# Access Compliance Report

## Public Rights-of-Way

### (Curb Ramps)

Intersection ID: 15045	Main Street: FAIRWOOD_AV	Cross Street: S_TRYON_ST	Location:	N
ADA ID: 93E25CBD41CC	Ramp Type: PerpDiag	Initial Pass/Fail: Fail	Overall Compliance: No	Severity Score: 37.5
Codes/Mitigation Info/Possible Solution		Field Measurements/Component Compliance

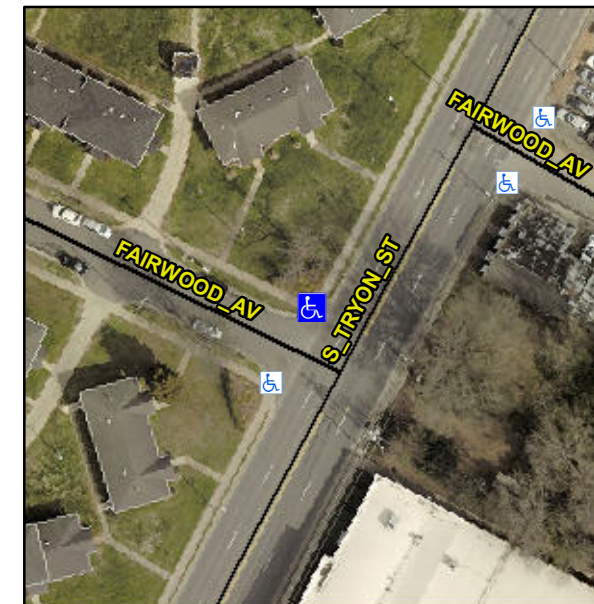
**Remove & Replace Curb Ramp With Two New Directional Ramps or Equivalent.**

**Not Found, R304.2.2, R304.5.3**

Compliance	Description	Data	Compliance	Description	Data
N/A	Ramp Length (in)	58.0	No	Ramp Slope (%)	8.8
Yes	Ramp Width (in)	48.0	No	Ramp XSlope (%)	9.2
N/A	Flare Type LT	N/A	N/A	Flare Type RT	N/A
N/A	Flare Slope LT (%)	N/A	N/A	Flare Slope RT (%)	N/A
N/A	Flare Traversable LT?	N/A	N/A	Flare Traversable RT?	N/A
N/A	Landing Length (in)	N/A	N/A	DWS Provided?	N/A
N/A	Landing Width (in)	N/A	N/A	DWS Contrast?	N/A
N/A	Landing Slope (%)	N/A	N/A	DWS Length (in)	N/A
N/A	Landing X Slope (%)	N/A	N/A	DWS Full Width?	N/A
N/A	Landing Curb? (Y/N)	N/A	N/A	DWS Offset (in)	N/A
N/A	Shared Landing?	N/A			
N/A	Gutter Ponding?	N/A	N/A	Gutter Slope (%)	N/A
N/A	Gutter Lip Ht (in)	N/A	N/A	Gutter X Slope (%)	N/A
N/A	Painted X Walk1?	No	N/A	Painted X Walk2?	No
	X Walk 1 Direction	To SW		X Walk 2 Direction	To SE
N/A	X Walk 1 Width (in)	N/A	N/A	X Walk 2 Width (in)	N/A
	X Walk 1 Slope (%)	1.3		X Walk 2 Slope (%)	3.4
	X Walk 1 X Slope (%)	6.0		X Walk 2 X Slope (%)	2.6
